post-flood discussion with SGB community members west of Capricornia Canal,
on 2 May 2022 (* indicates name and contacts withheld)

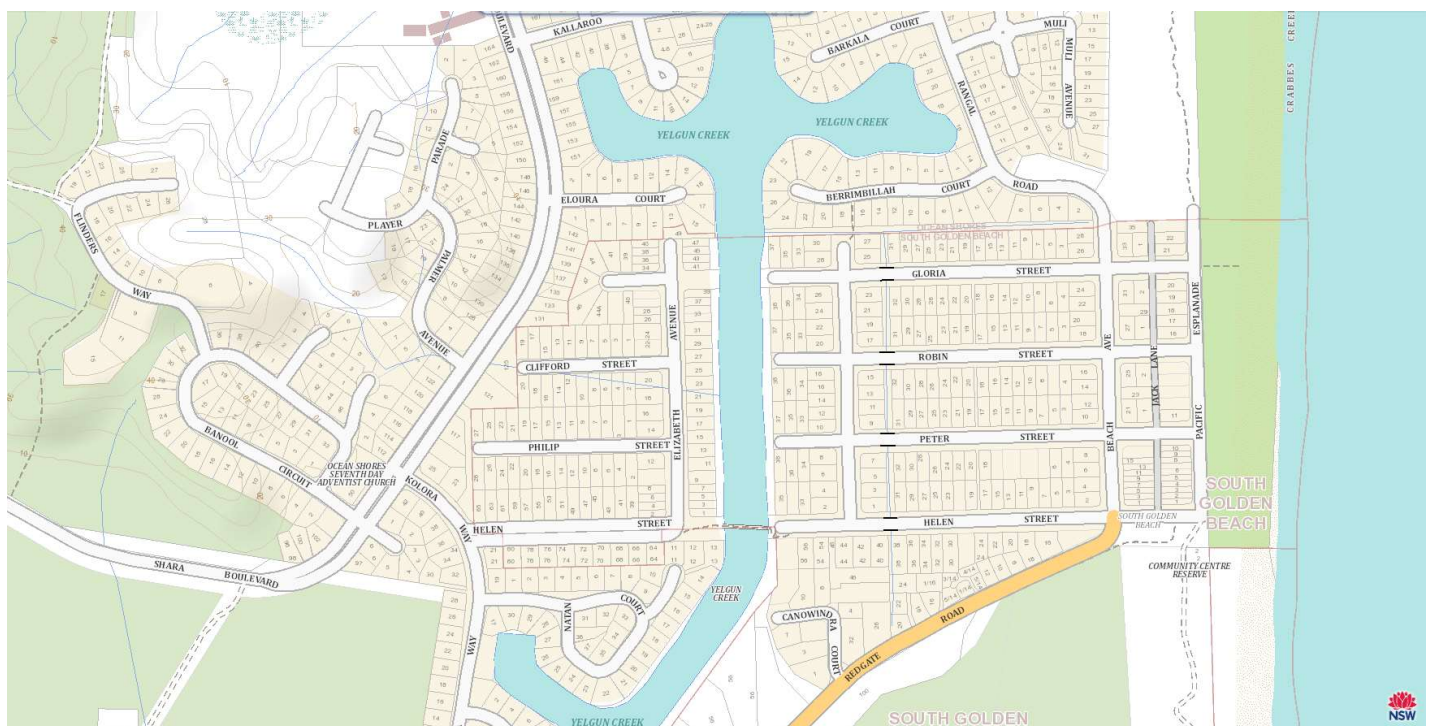
The corner of Elizabeth and Clifford Streets must be a sag-point for stormwater. Nearby residents*³ report that water sits in the table drain above grate level for weeks at a time after significant rain.

Would staff please talk to them (contacts through me) and design and then build a remedy? This may require piping north or south down Elizabeth Street, to one of the backyard easements.
